Town of Duanesburg
Planning Board Minutes
October 19, 2023
Final Copy

Re: Town of Duaneburg
Wishy Wash Site Plan & Special Use Permit Review
Amendment #3 for Engineering Services

In response to the new comments (*in italics*), (previous comments unaltered font) of Doug Cole of Prime AE of April 12, 2023, we respond as follows (**in bold**):

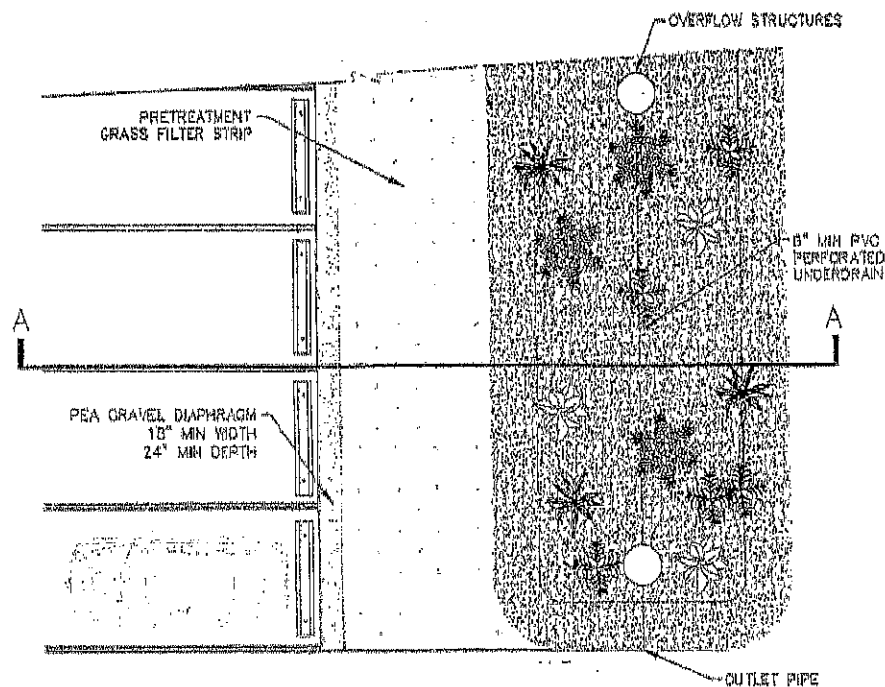
2. The proposed bioretention practice shows a 6" underdrain pipe to daylight discharging to the south of the facility onto lands of the applicant and a 12" HDPE outlet pipe and emergency spillway from the facility are shown exiting to the east onto lands of Thomas into an existing drainage swale which then flows through lands of Chilton prior to joining a stream that flows under NYS Route 20 near Gage Road. We have learned that a similar gravel parking area project was reviewed and approved by the Planning Board last year with a different stormwater design that kept all stormwater discharges on site, however, the design was not constructed as approved and the Town Permit was rescinded. In the December 15, 2021 letter to Dale Warner from Brett Steenburgh, P.E. regarding neighbor property flooding due to prior work performed on the gravel parking area, we located a statement attributed to Jamie Malcolm, NYSDC Region 4 which said he "suggested that they maintain the existing drainage pattern and drain the pad to the southeast corner and not try to create the swale towards the car wash driveway and down US Route 20 ... as it may cause problems within the highway drainage system and inundate the existing culverts under the driveways of Wren and Chilton." We have not verified this statement with Mr. Malcolm, however, it is in keeping with NYSDC requirements that the project design must ensure that there is no increase in runoff from a new development project and that there are no adverse effects downstream of the project. We understand that a bioretention practice has

been designed to mitigate the offsite impacts of this project, however, since there are known issues with the current drainage pattern, we ask that the applicant provide additional information why the original plan to keep discharges on site are not practical if proper stormwater management practices are put into place to mitigate effects on the Route 20 drainage system and neighboring driveway culverts. Please also refer to our further comments on the stormwater design in the Drainage Narrative section of this letter. *We have read the response to this comment in the 10/7/22 response letter from ABD, which did not answer the question above. Additionally, there are still concerns as noted below:*

- a. There needs to be test pit data that shows the proposed bottom of the Bioretention practice will be at least 2 feet above the high groundwater table. There is a note on the detail for the practice about using a poly-liner if the separation cannot be met, but this should be known at this point in the process. *The applicant has stated that groundwater is expected 18" below the surface and that is why a poly-liner has been selected. We accept this response.*

- b. Review of the Stormwater Design Manual (SWDM) shows that Bioretention is an acceptable practice for water quality treatment but is not to be used for water quantity control. An appropriate quantity control practice needs to be included for this project. *Please refer to comment 5.e under SWPPP section.*
